## ADDENDUM NO. 1

PROJECT NAME: **Huebner Creek Greenway Hike and Bike Trail Extension – BID #2026-01  
(CSJ 0915-12-735)**

DATE: **January 27, 2026**

## TRAFFIC CONTROL PLAN LANE CLOSURES ON MULTILANE CONVENTIONAL ROADS

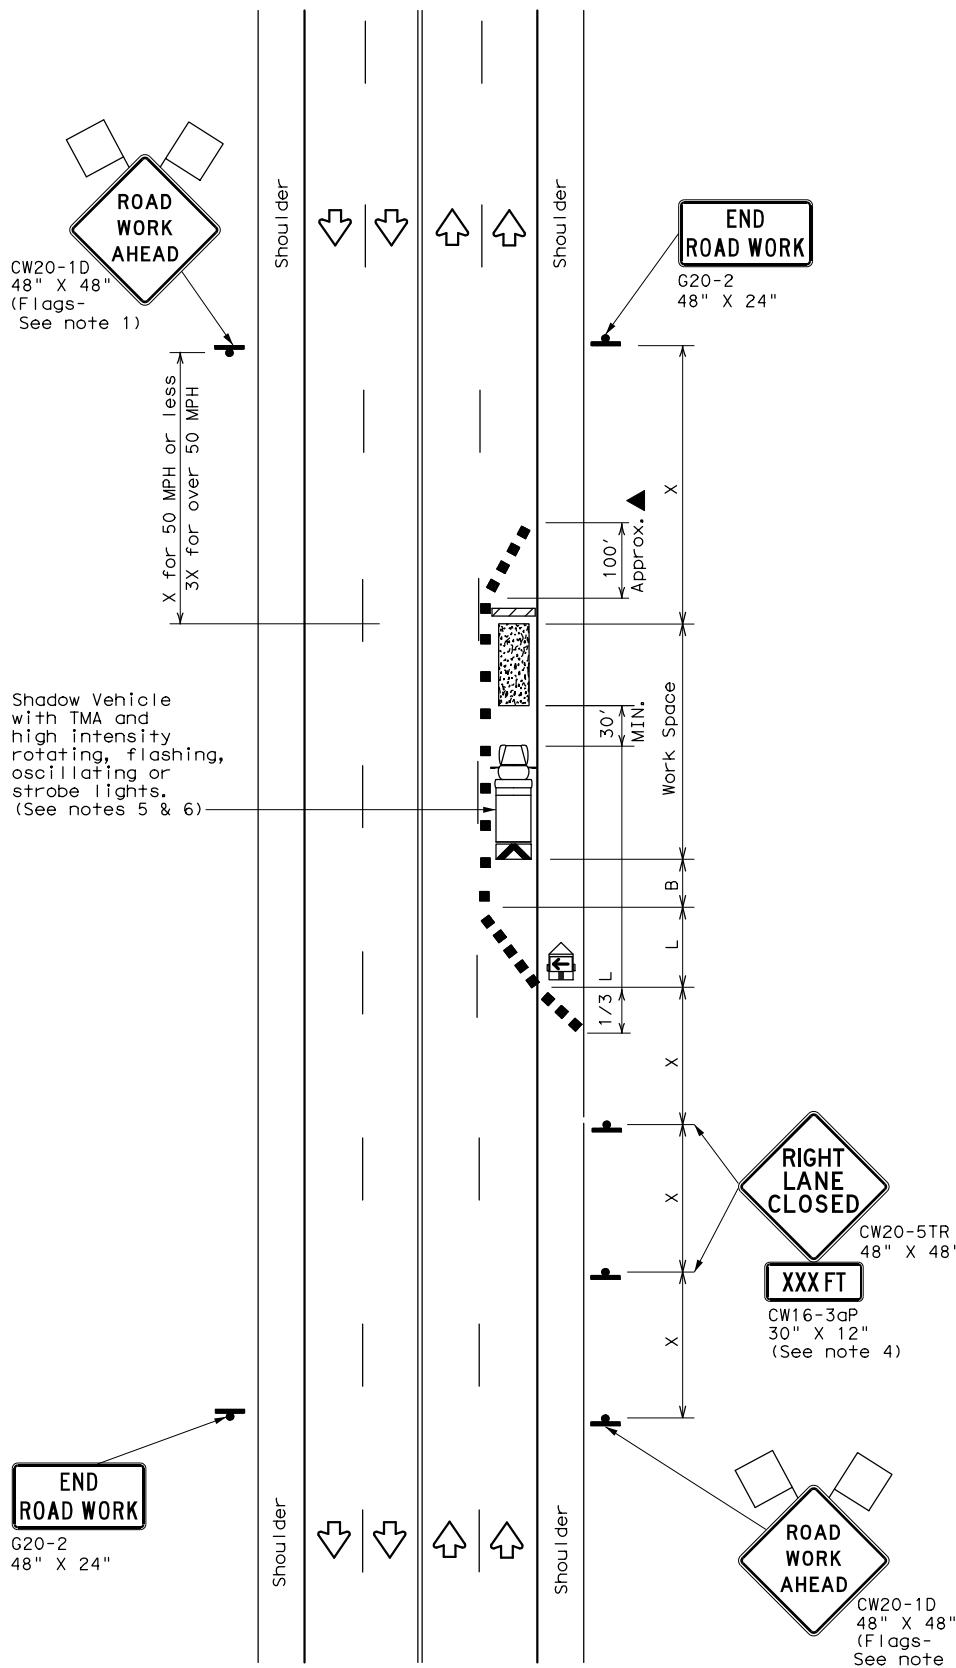
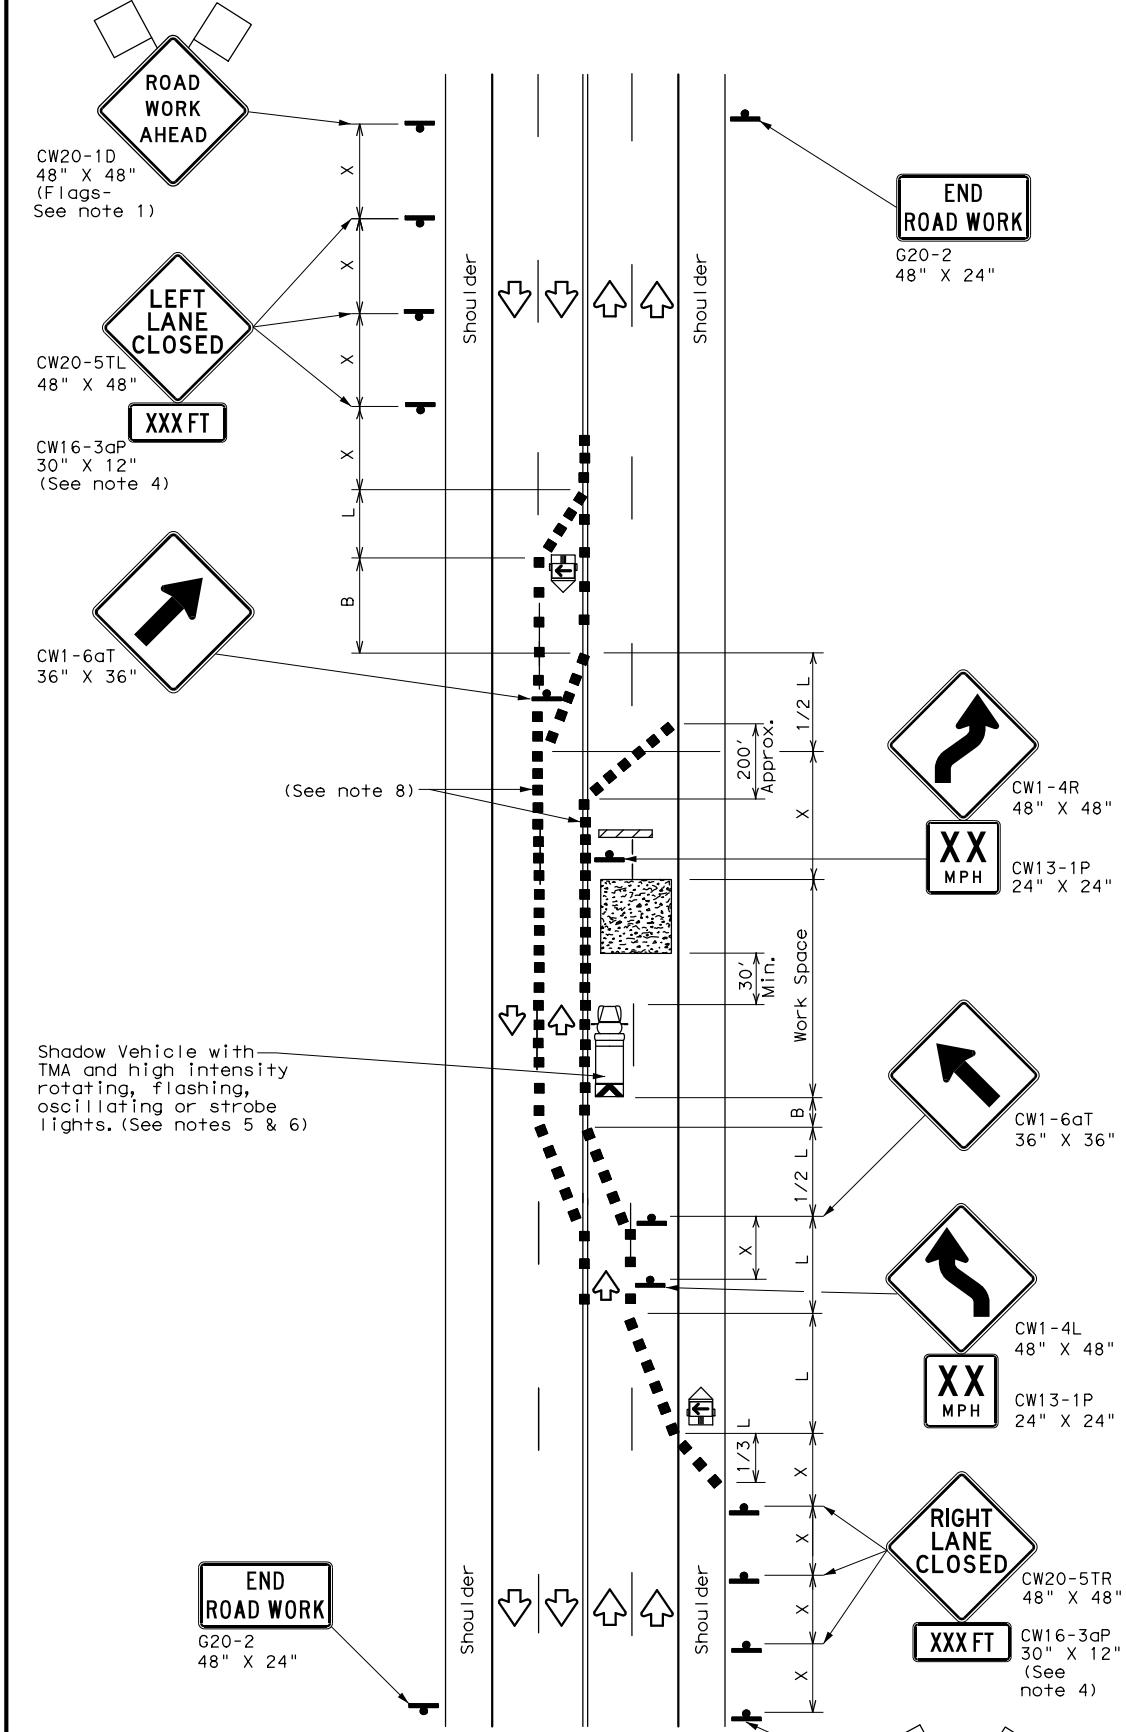
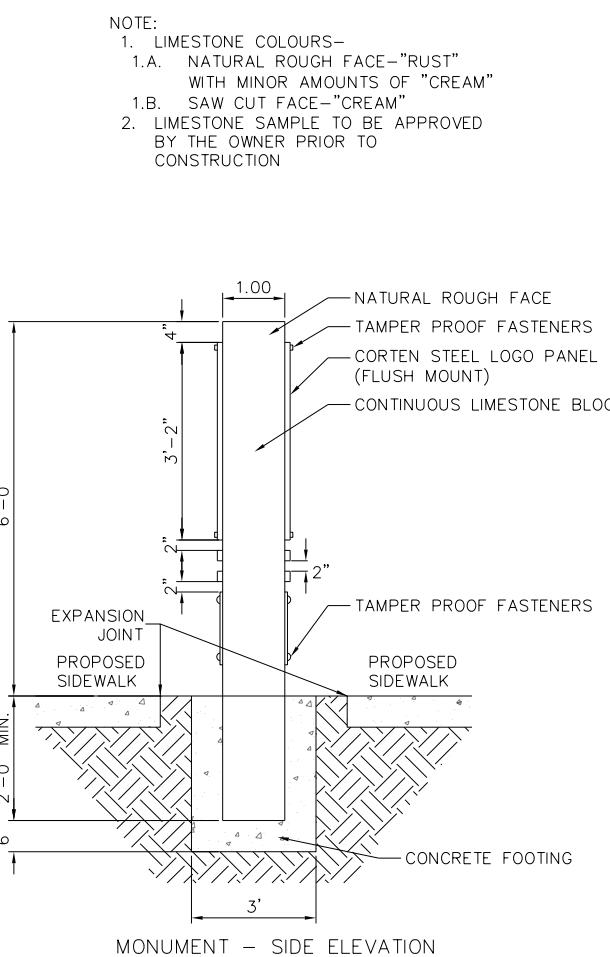
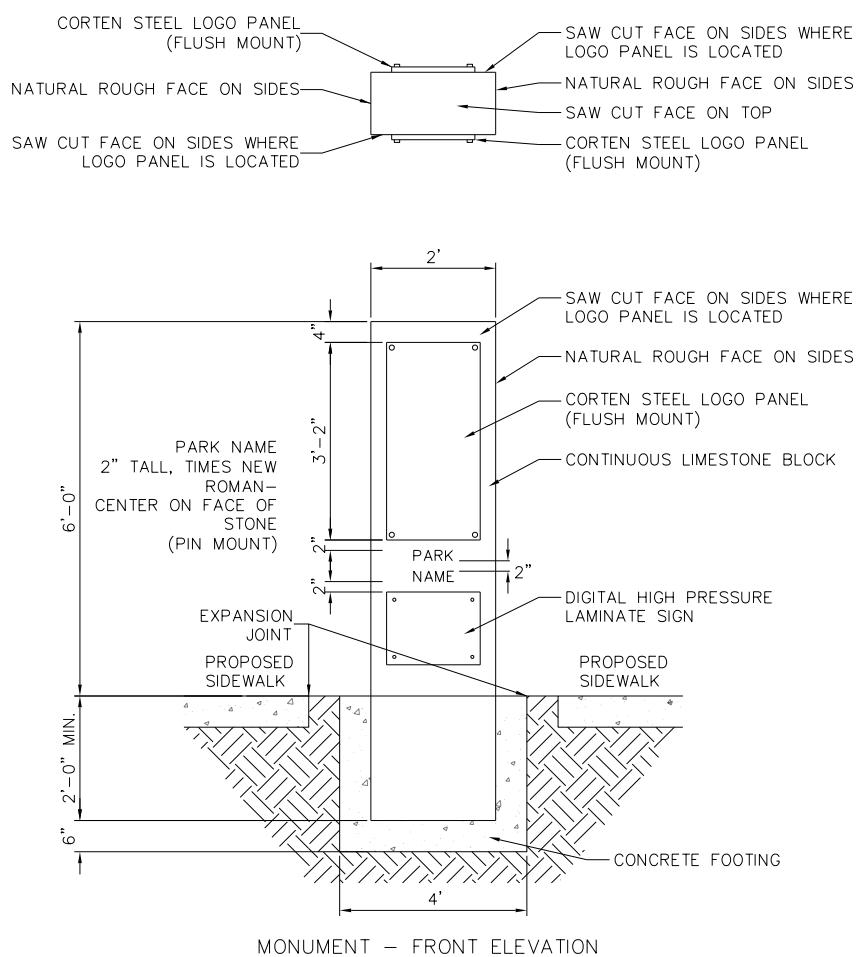
- a. This is being clarified with Addendum #1. TCP will be required for work on the Evers Rd tie-ins with a one lane road closure.
4. Will a temporary aggregate sidewalk be required for the full length of the project?

13. Remove and Replace Pages 17, 18, and 19 of the Plan Set to add location of temporary sidewalk.
14. Add Page 31a to the Plan Set to include TxDOT Standard TCP(2-4)-18.
